## Objections to Staff's Analysis of Hauling Practices (Tech Memo #5)

## Supplement to Response 29 Waste Flow Trends

Figure 1. Staff's analysis of the waste flow trend in the Malibu Civic Center area. (Same as Technical Memorandum #5, Figure 2)

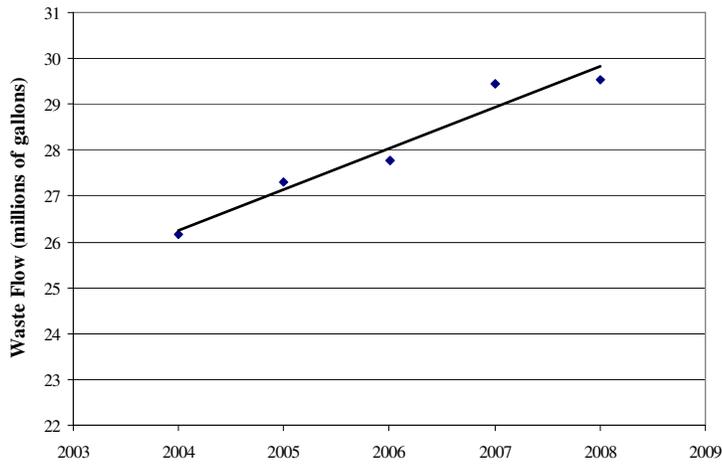
On October 8, 2009, Malibu Bay Company (Colony Plaza) objected to staff's analysis of waste flows (Figure 1). Colony Plaza alleges that Appendix A: Septic Waste Flow and Hauling Data (TM5-12) contained incorrect values related to its facility. Colony Plaza specifically questioned the assumptions made by staff on the waste flows from the facility for 2004 and 2005. Staff's methodology of assumptions is explained in Technical Memo #5, footnote 3. Where data are missing from monitoring reports, staff made reasonable assumptions using best professional judgment.

Figure 2 varies greatly from Figure 1. Staff estimated waste flows for Colony Plaza using the methodology described on footnote 3 of Tech Memo #5. In 2006, only the waste flow value for the fourth quarter was available. Staff multiplied this value by four to get an estimate for waste flows for the entire year. Staff estimated the waste flow for 2008 based on the data from the first and second quarters, which were available. The sum of waste flows reported for the first two quarters was doubled to provide an estimate for the entire year's waste flow. Using these assumptions, waste flow estimates for years 2006 through 2008 showed a steady annual increase. These values were extrapolated back to years 2005 and 2004, to get an estimated waste flow of 5 million gallons per year. These data were included in Figure 1, which shows the annual waste flow trend for the Malibu Civic Center area.

Figure 2. Colony Plaza's adjusted analysis of waste flow trend for the Malibu Civic Center. using waste flow data provided by IPC for Colony Plaza.

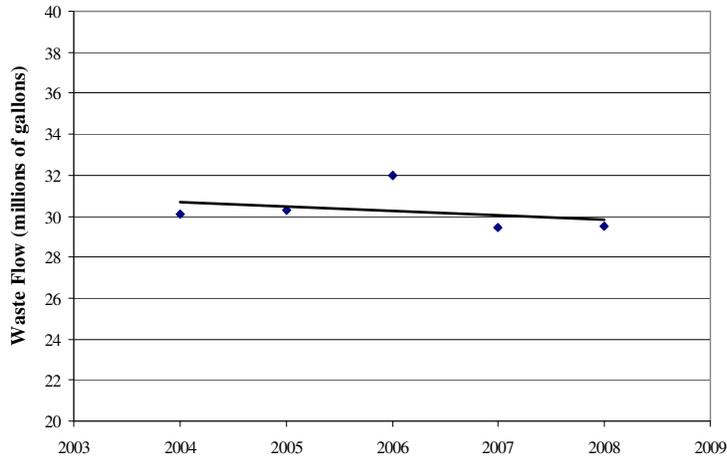
Integrated Performance Consultants (IPC) on behalf of Colony Plaza adjusted Colony Plaza's waste flows (Figure 2). IPC estimated that in 2004, Colony Plaza discharged 8,946,516 gallons, assuming that between January and August, the facility discharged the same amount of septic waste as it did from September to December 2004 (2,982,172 gallons, shown on Colony Plaza's pumping records). IPC also estimated that in 2005, Colony Plaza discharged 11,753,171 gallons. IPC's estimates were based on pumping records for the first 11 months of the year and best professional judgment, assuming that the volume of waste pumped in December is similar to the volumes pumped during the first 11 months of the year. (This is the same approach that staff used.)

In order to generate complete data sets for the analysis of annual waste flows in the Malibu Civic Center area, staff extrapolated from available data. IPC submitted data on waste flows and annual water consumption. IPC reported that in 2004, 8,946,516 gallons of septic waste were discharged, which is 68% of the 13,126,161 gallons of the water consumed. (IPC did not account for the missing 4,000,000 gallons.) In 2005, IPC reports that Colony Plaza discharged 11,753,171 gallons and consumed 11,7432,673 gallons (higher waste flow than water use). Staff adjusted the waste flow value for 2005 to be consistent with the value reported for 2004, which assumed the waste flow was 68% of the potable water consumed.

Figure 3. Waste flow trend for the Malibu Civic Center area, excluding waste flows from Malibu Colony Plaza.

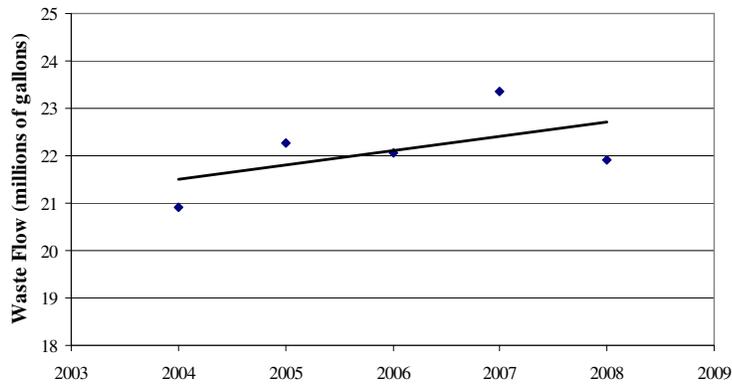
38	Appendix A (Septic Waste Flow and Hauling Data) of Tech Memo # 5 contains incorrect values.	Colony Plaza	268 § 4	Disagree. Staff considered new data (page 272), but was unable to resolve conflicting assumptions (See Supplement). <b><u>Staff further analyzed the waste flow trend, ignoring the Colony Plaza flows. This revised trend line still shows an increasing trend.</u></b>
39	Tech Memo #. 5 conclusion that hauled volumes are increasing is incorrect.	Colony Plaza	269 § 3	Disagree. Staff analyzed the hauling trend for 13 permitted facilities. Colony Plaza asserts that its waste hauling is going down. This does not change the trend for the 13 permitted facilities.
40	Regional Board's calculation of daily waste flow was inaccurate.	Gerson	314	Disagree. Technical Memo No. 5 did not include Morton Gerson-Colony Plaza in its analysis of waste flows and hauling because of the small amount of waste flow generated.

As staff was not able to reconcile discrepancies, staff also analyzed the trend ignoring Colony Plaza's flows. Colony Plaza is one of thirteen commercial dischargers that were included in the analysis. Colony Plaza is the second largest discharger among the thirteen commercial dischargers (Malibu Water Pollution Control Plant is the largest); therefore, its waste flow has a significant impact on total annual waste flows. This explains the opposite trends shown in Figures 1 and 2. However, **even when the Colony Plaza is eliminated from the analysis, an increasing waste flow trend for the Malibu Civic Center area still remains** (Figure 3).
